SPECIFICATIONS - Entry J01
RHK6581 Lee Smith

Kitchens By Resident Hero 32 Gateway Drive Phone: 0754471077 mark@residenthero.com.au www.residenthero.com.au	RHK6581 Lee Smith	**Scale: 1 : 20**	**Sheet 1 of 3**
	Entry J01	Do not scale off this drawing.	Drawn By:
	38 Howard St, Grange QLD		Date: 26/10/26

Entry J01 Elevation Wall 1 1 : 20

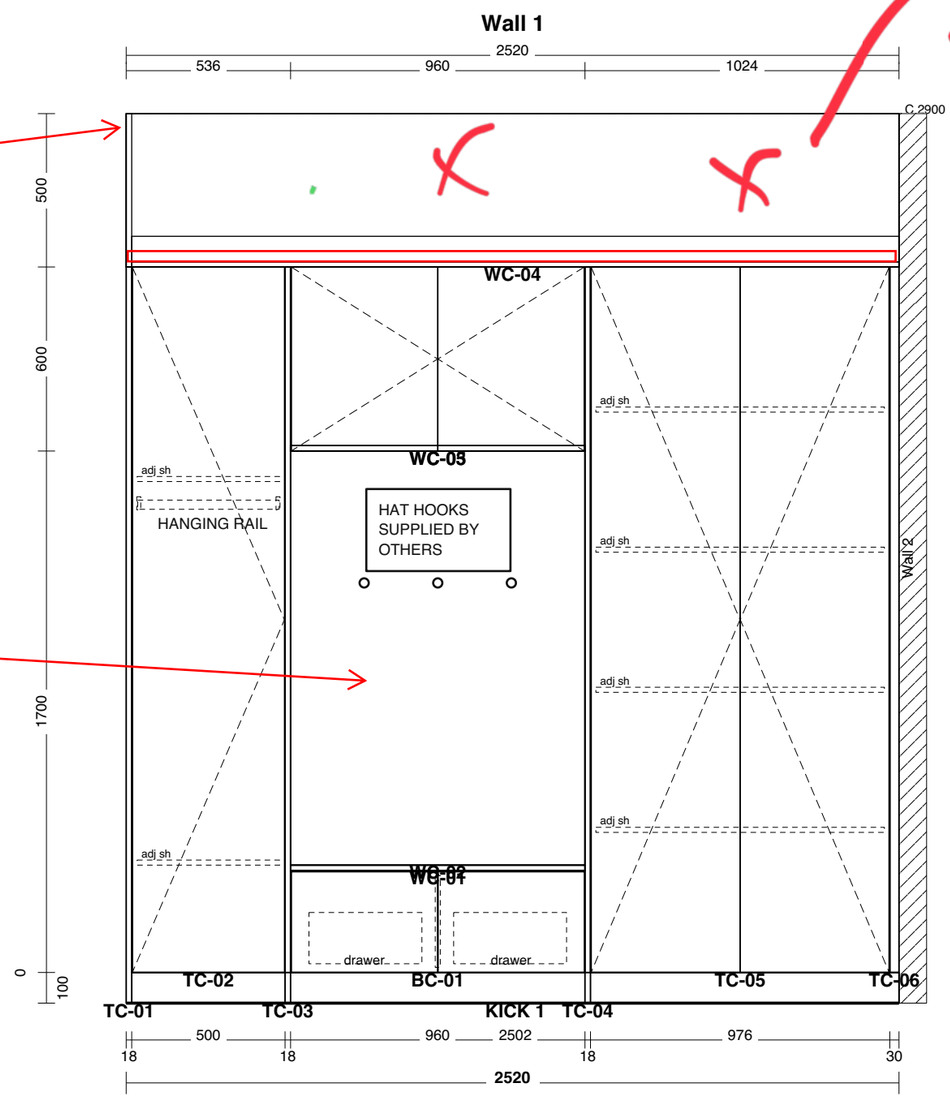
bulkhead not needed to this joinery piece. flat top panel only in elegant oak

confirm elegant oak panel to rear

Delete BH
Top Cap
Joinery

Entry J01 3D NTS

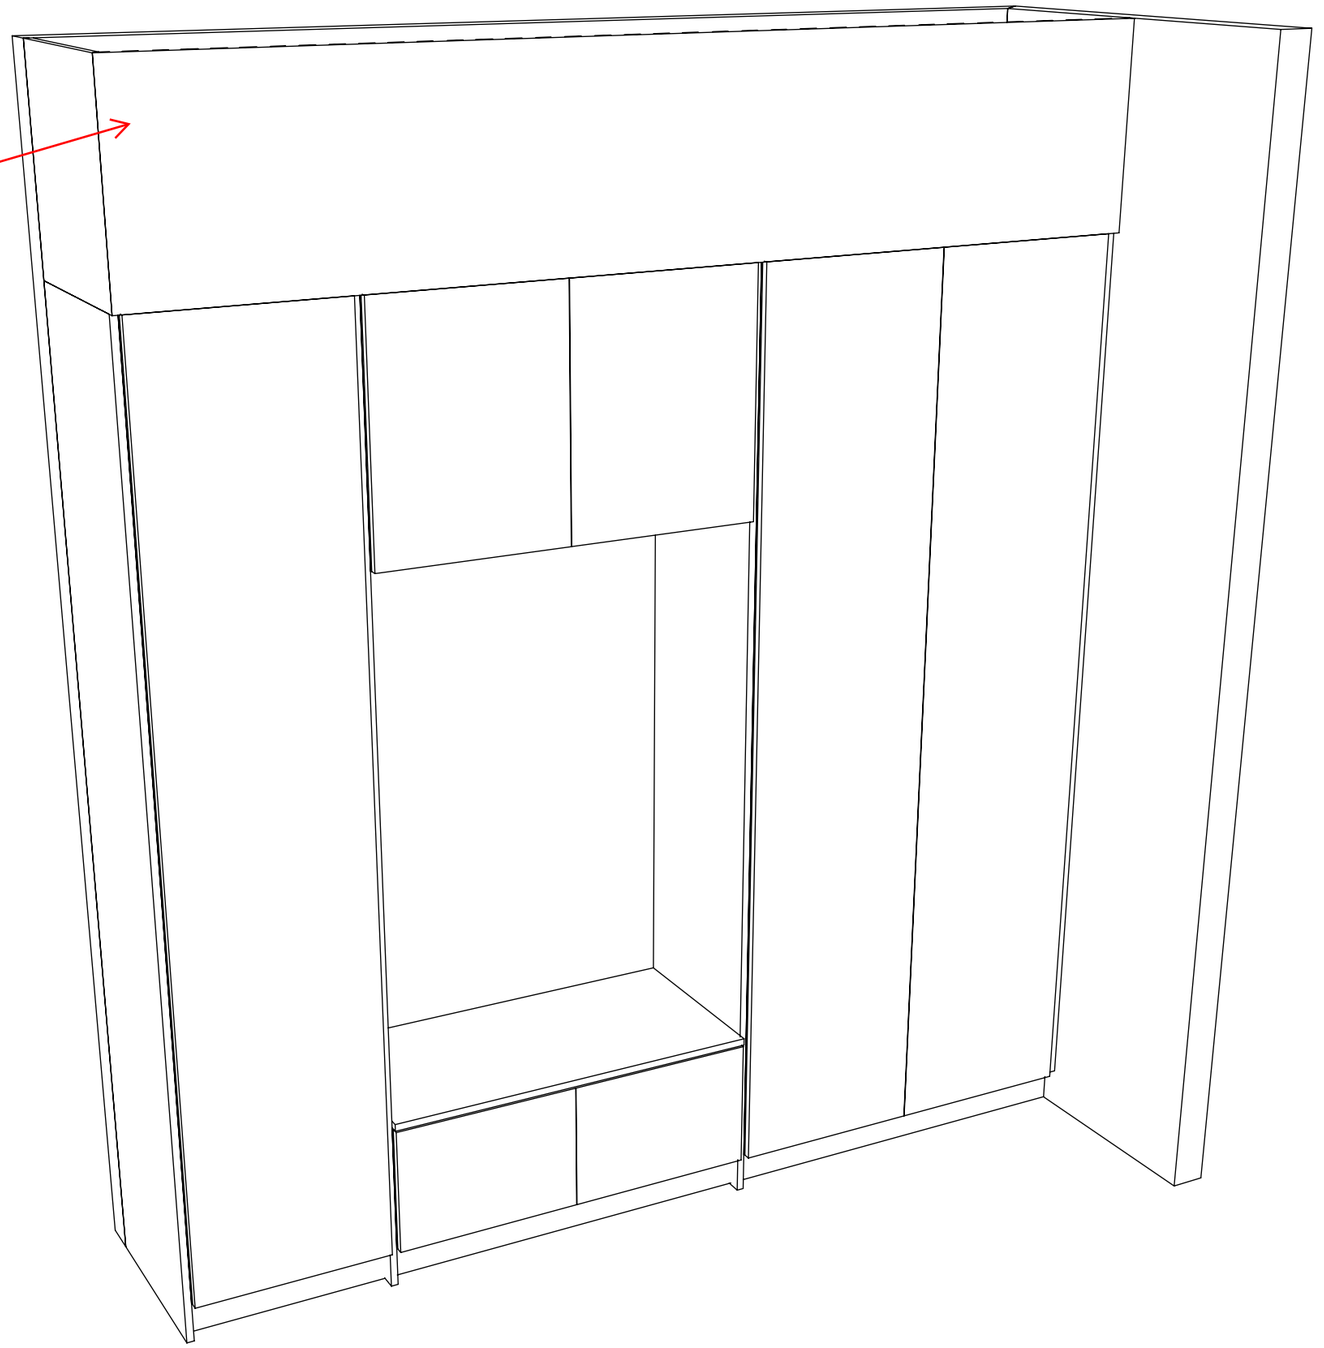
no bulkhead to top of joinery. flat panel (elegant oak).
